UNITED STATES OF AMERICA
NUCLEAR REGULATORY COMMISSION

(License Renewal for the Oyster Creek
Nuclear Generating Station))

Docket No. 50-0219-LR

**CITIZENS' INITIAL STATEMENT REGARDING RELICENSING OF OYSTER
CREEK NUCLEAR GENERATING STATION**

Bay 19 External 2006 UT Measurements, Minimum Values

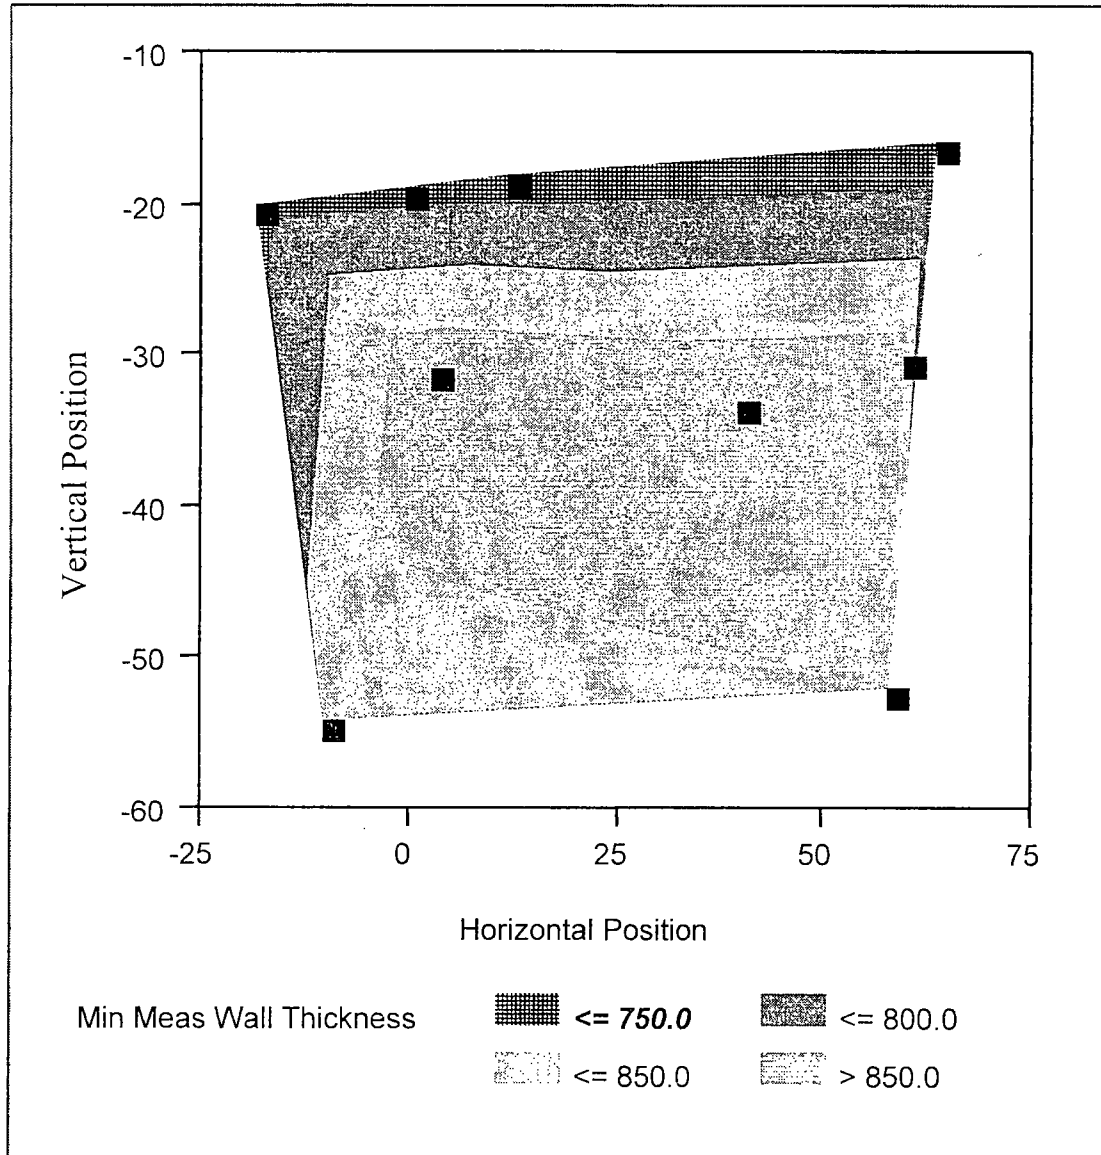
The advantage of this evaluation is that one can see all the available data in a quantitative presentation. Thus, one can see in Figure 1 that an area exists at elevation -20 (20 inches below the reference point) where the remaining wall thickness is less than 750 mils, or less than the criteria for general thinning at 95% confidence. This area extends from 20 inches on the left (-20 inches) to about 60 inches on the right (+60 inches), or about 7 feet. The width of this area in Fig. 1 is maybe 4 to 5 inches, however, because measurements were not extended toward lesser elevations (from the reference point) one simply cannot estimate how much further the serious the corrosion may extend in Bay 19.

Figure 1 mentioned previously shows a heavily corroded area in Bay 19 at elevation -20 . The extent of this area is highly uncertain because it was not further defined by additional UT measurements toward higher elevations (>-20). Indeed, one could find here an extended bathtub ring area.

Figure 2
 Bay 1 Remaining Wall thickness
 External UT Measurements 1992/1993

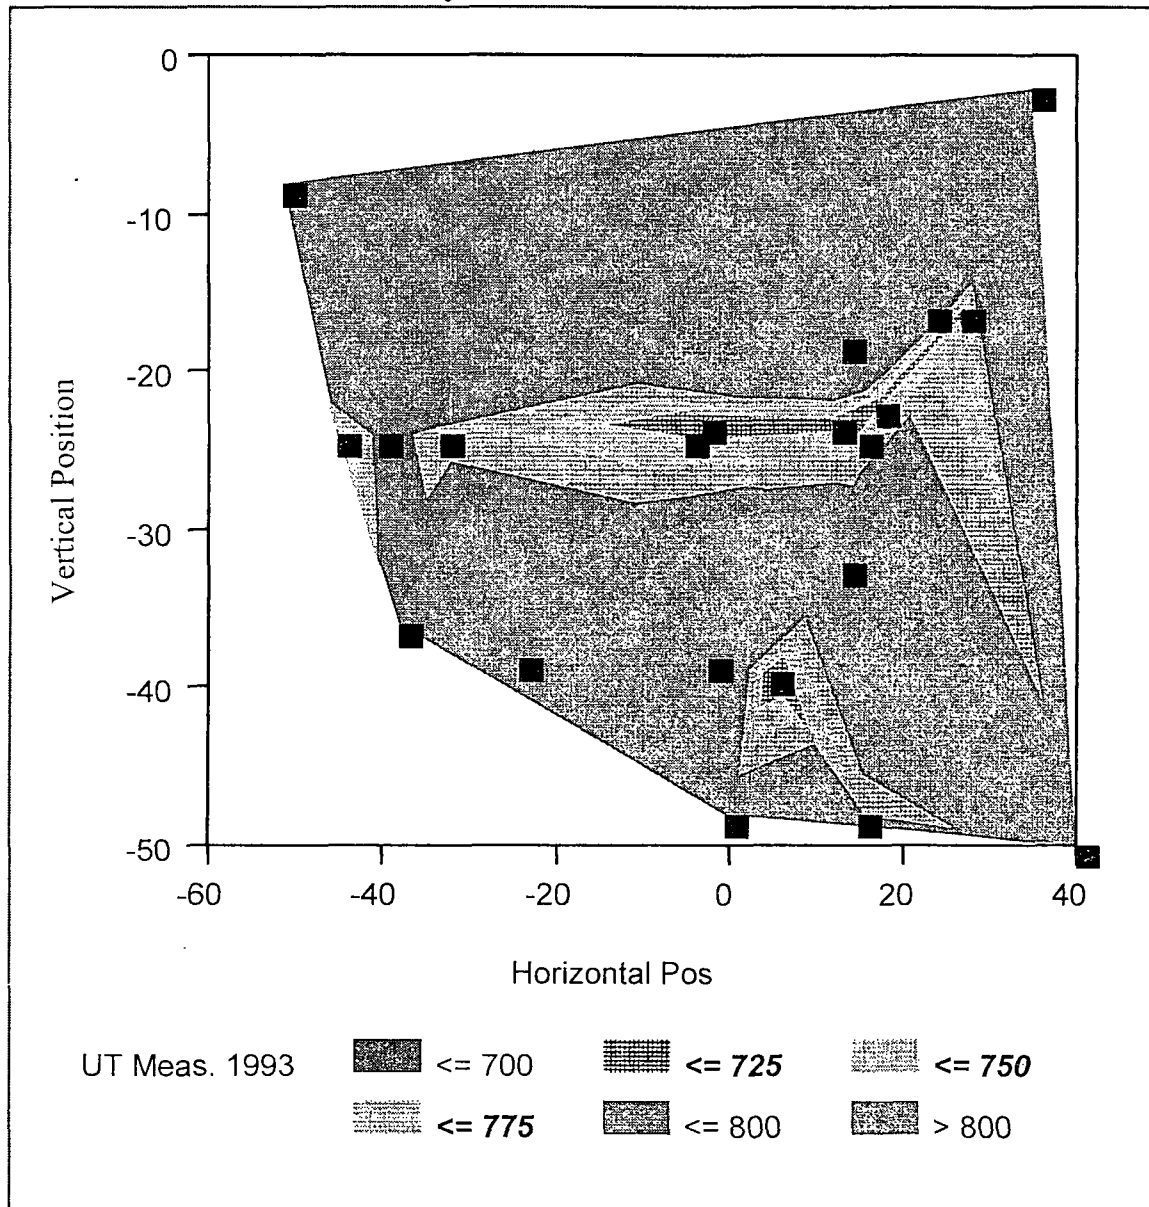
The data used for the analysis are contained in Tables 1 and 2 for Bays 1 and 13 as extracted from AmerGen documents. Presumably, these were the most corroded Bays. Figure 2 shows a contour plot for Bay 1 obtained with the data from 1992. The dimensions of the points in the plot are 2.5 by 2.5 inches. Again, one needs to remember that the specific shape of the contours depends not only on the residual wall thickness measured at the locations indicated, but on the density of measurements as well. (For instance, an additional measurement at coordinates h (-20) v (-25) could completely alter the contours and in all likelihood extend the area of wall thickness below -750 mils ⁴⁾.

Nevertheless, it appears in Figure 2 that in the so called "bathtub ring" an extensive area exists with wall thicknesses between 700 and 750 mils (0.75 inches). This area extends well over 52 inches (4⁺ feet) and is about 5 inches wide. In view of the fact that UT measurements are at best accurate with a standard deviation of about 45 mils, (95% confidence limits +/-90 mils), this area could well be more extensive.

Bay 1 Remaining Wall thickness
External UT Measurements 2006

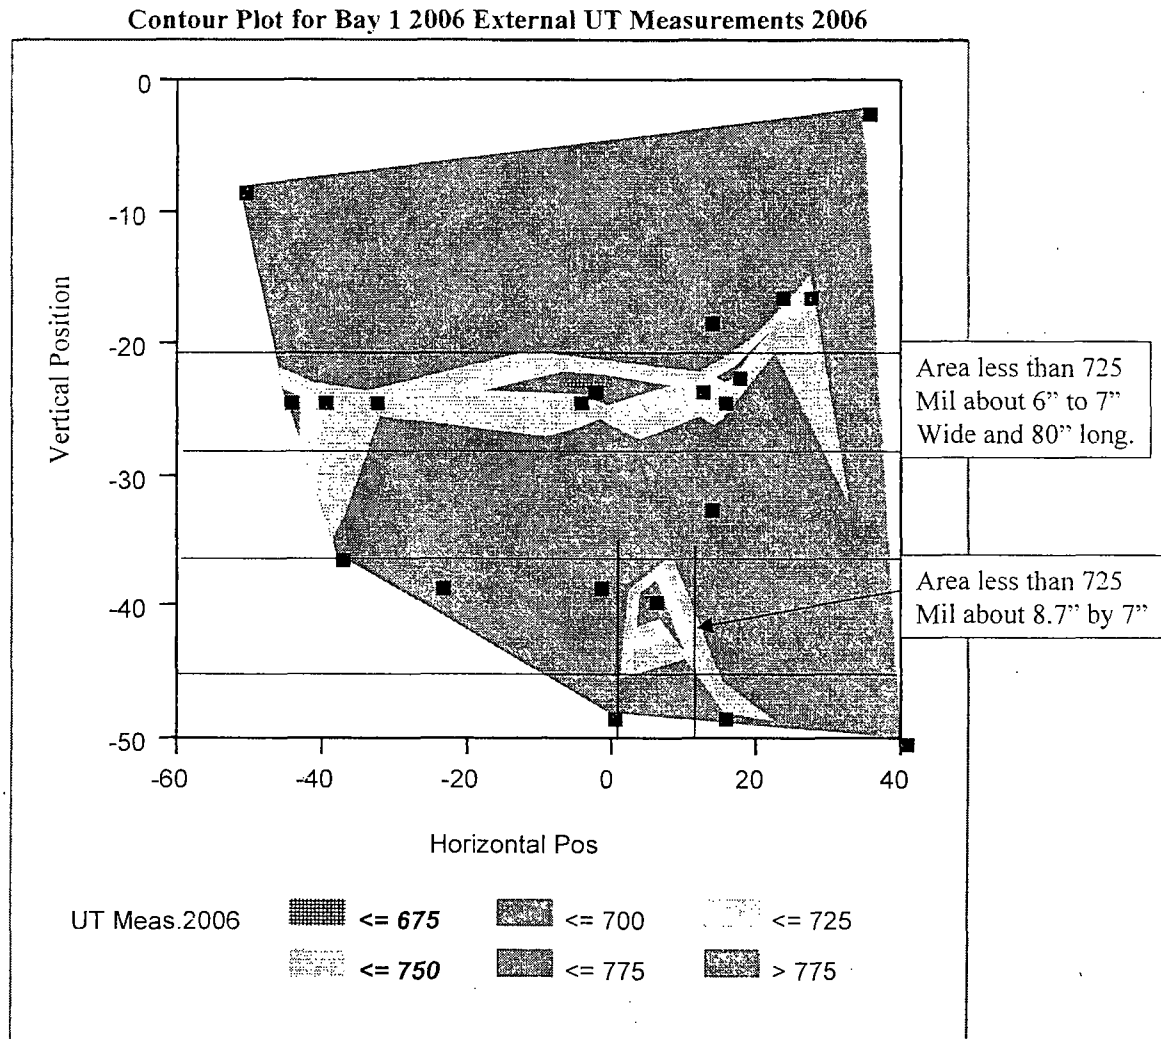
Figure 3 shows the contours for Bay 1 obtained with the data from the 2006 inspection. The general shapes are the same as in Figure 2 except that here we have sizeable areas with residual wall thicknesses below 725 mils. The unexpected thing is

Based on Figure 3, together with an assessment of the accuracy (reliability) of the data one must conclude that there is a good likelihood that the entire bathtub ring area extending from 40 to -40 inches on the horizontal axis and from about -30 to perhaps -20 inches on the vertical axis is below the 0.736 inch criteria for general thinning and is, much larger than the one square foot acceptance criterion. (Of course, since this area is the most corroded, it will taper off to higher wall thickness on both sides of the vertical axis). The corroded area is indeed shaped quite irregular, but one could venture a guess that the contoured areas below 750 mils are of the order of 4 to 7 square feet all together. This estimated area does not include the area to the left of -40 , which probably contains additional area below 0.750 inches.

Bay 13 Remaining Wall Thickness
External UT Measurements 1992/1993

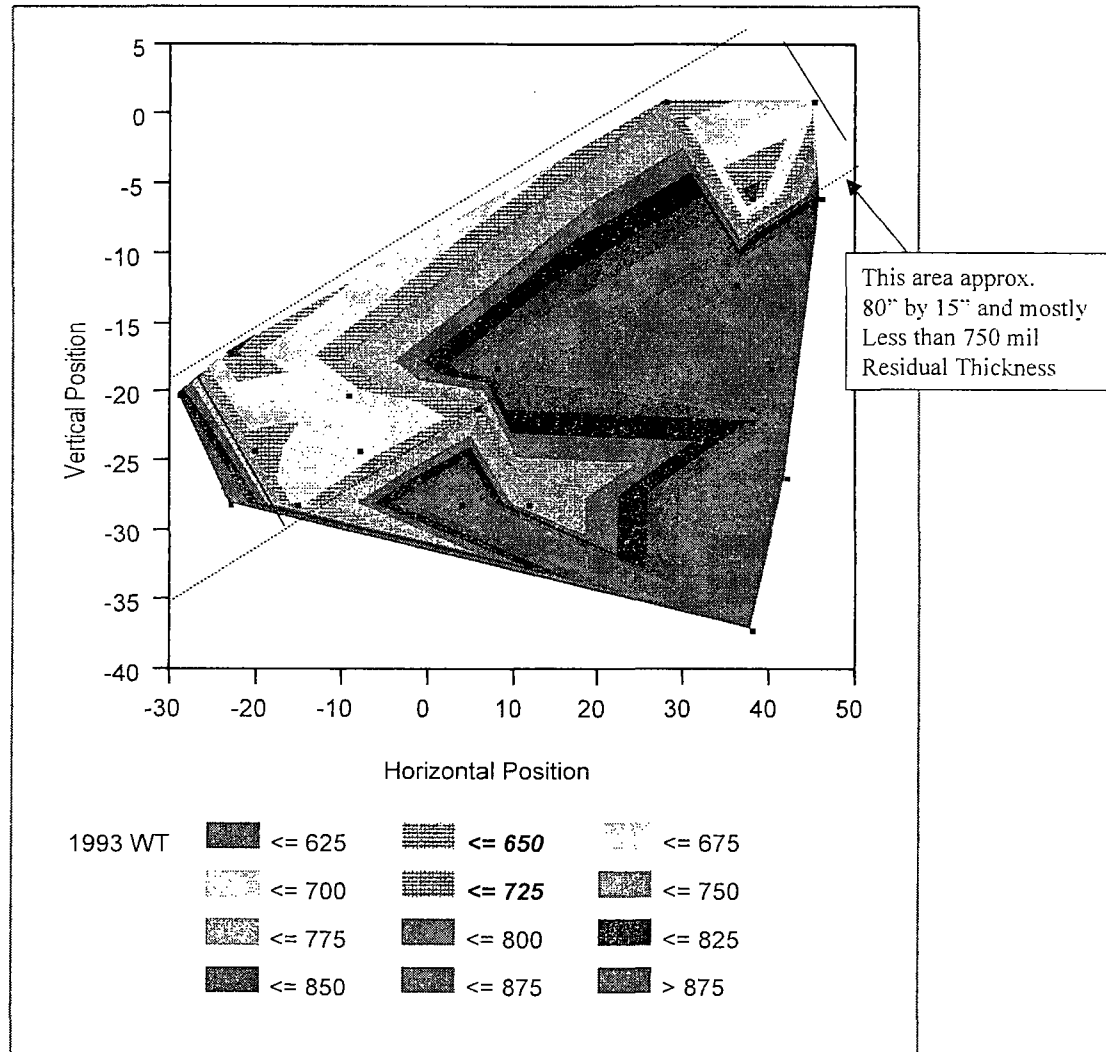
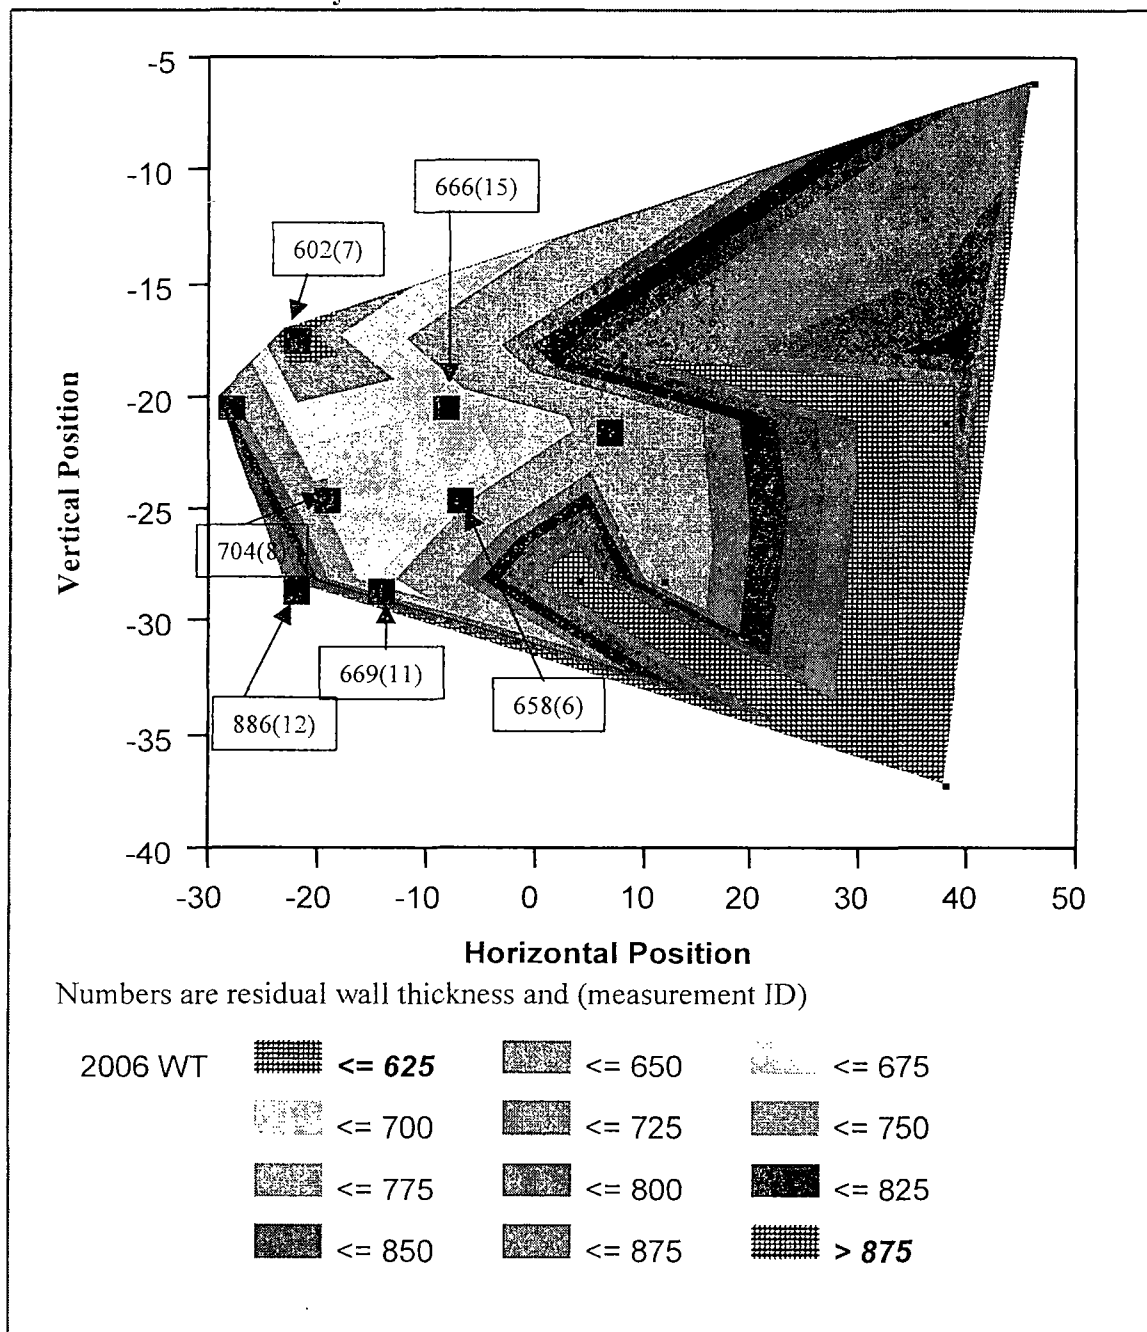
Figures 4 and 5 show the contours for Bay 13, 1992 and 2006 data, respectively. Here large areas exist with wall thicknesses below 700 mils and at least two seemingly unconnected areas where the residual wall thickness is less than 650 mils. It could be argued that those heavily corroded areas are less than 1 square foot and therefore are still acceptable according to the 636 mil criterion. However, the heavily corroded area on the left hand side (-20 , -20) has not been further explored. One therefore does not know whether it might extend further. Similarly, the area on the right ($(40, -7)$), clearly showing a fairly deep pit, was not further explored and was not even measured in 2006. While in Bay 1 the bathtub ring was at elevation -20 to -25 (from the reference point) in Bay 13 there is no clearly prominent bathtub ring. This may be because it was not there, but it may also be because the measurements were not extended toward elevation -15 and -10 . We are therefore left with a great uncertainty as to the true extension of the damage in this Bay.

Contour Plot for Bay 15 2006 External UT Measurements

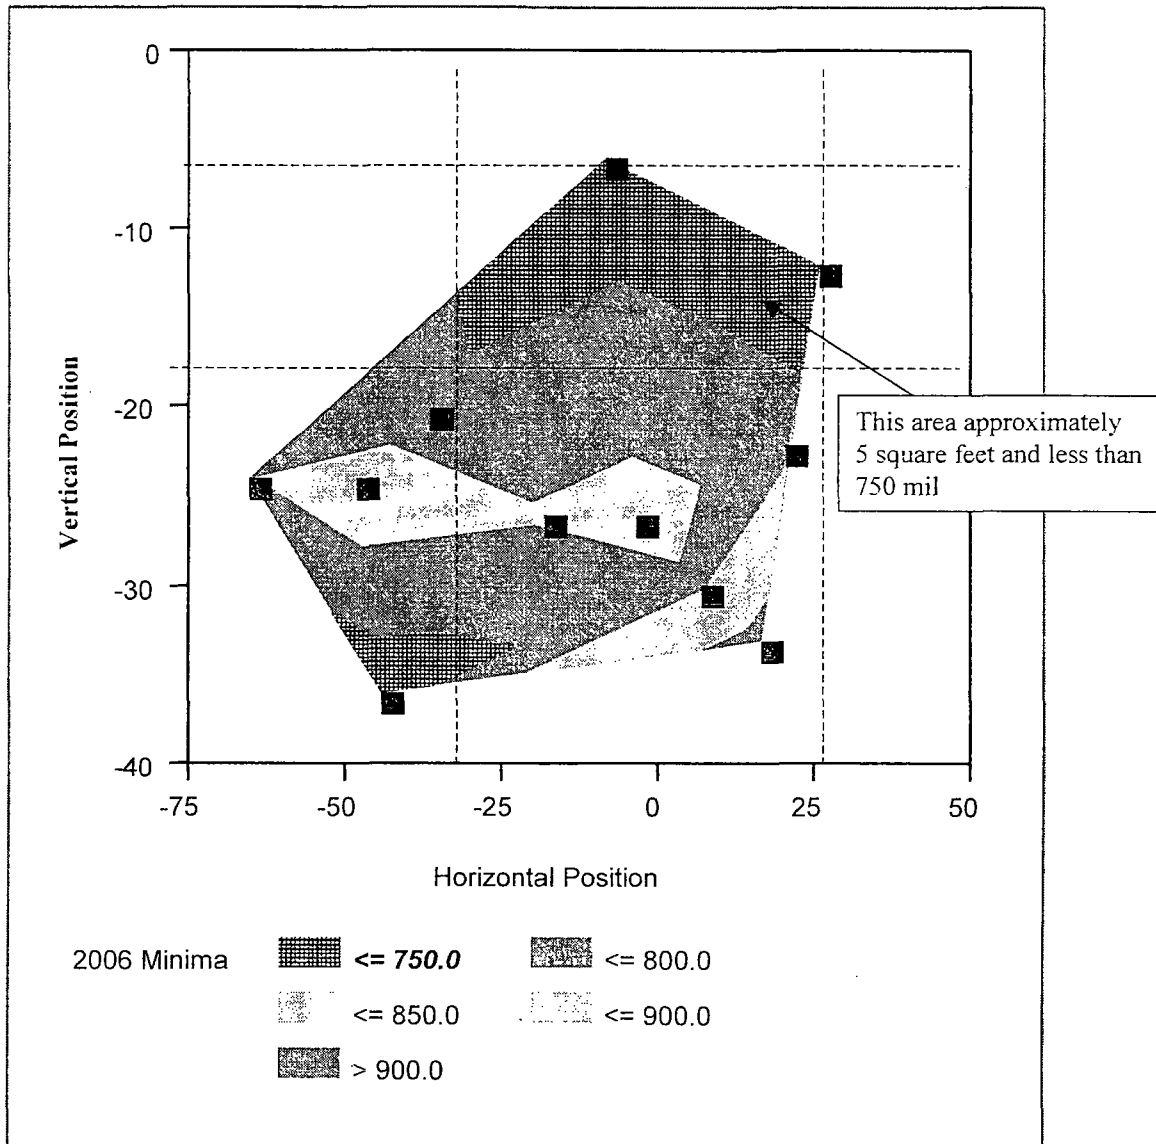
Figure 6 shows the contours for Bay 15. There is a heavily corroded area at elevation -10 with an extension of 1 ft by about 4.5 feet. However, this area was explored only with 2 measurements and was not extended beyond about 2 feet either side of the centerline. It appears that the majority of the measurements occurred in the non-corroded zones. Interestingly there appears some serious corrosion near the sandbed bottom, but the occurrence was not further explored either.

Figure 7
 Contour Plot for External UT 1992 Data Bay 11

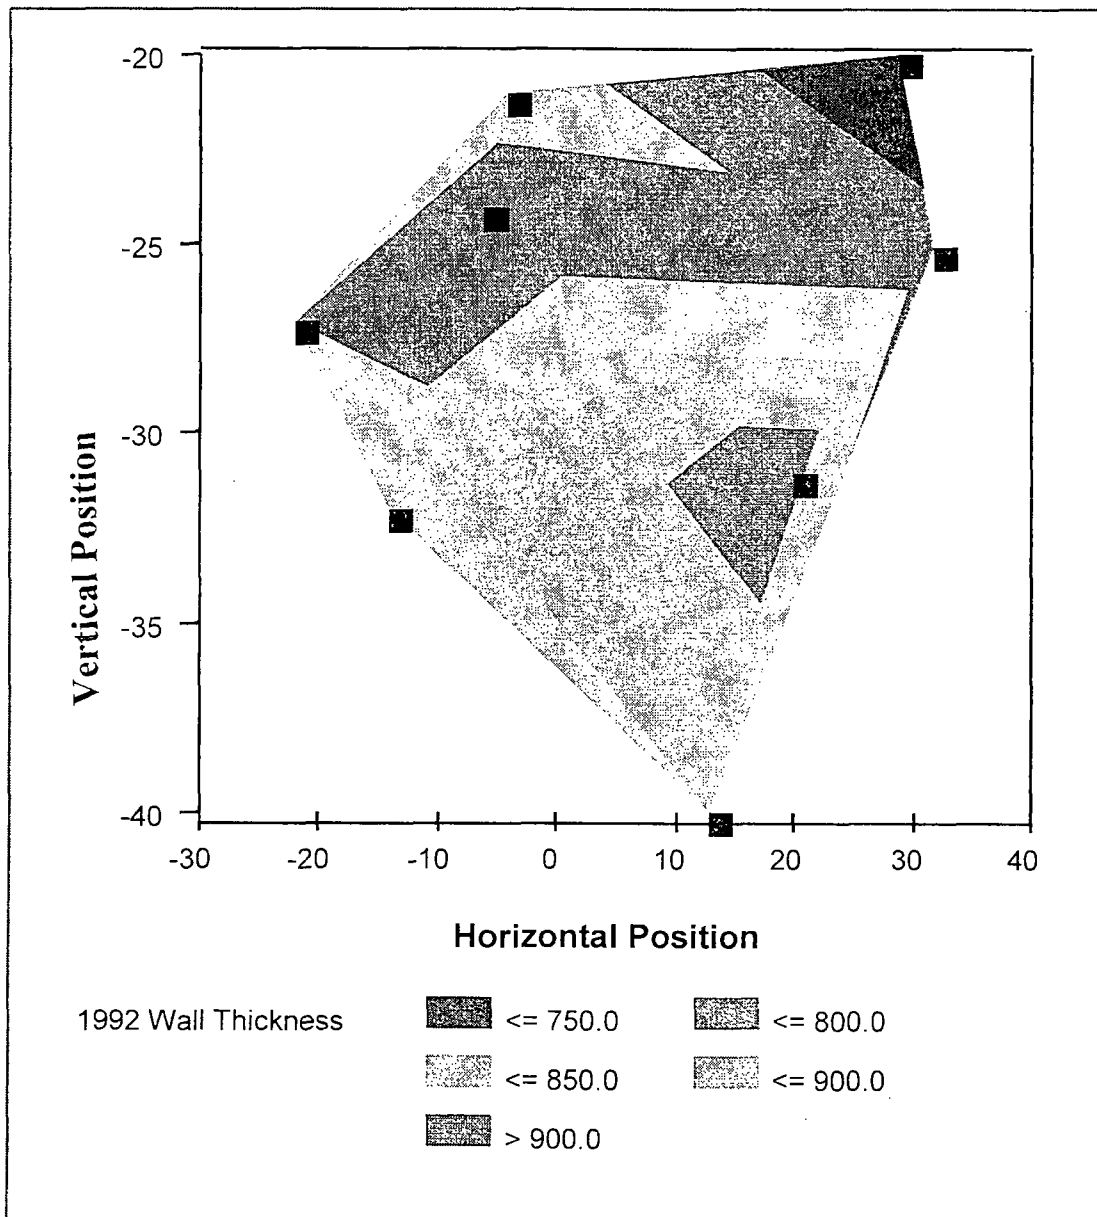
Figure 7 shows the contours for Bay 11. Again there is a suggestion of severe corrosion at elevation -20 and no further exploration into the bathtub ring area. Once again, the extent of this area is highly uncertain because it was not further defined by additional UT measurements.
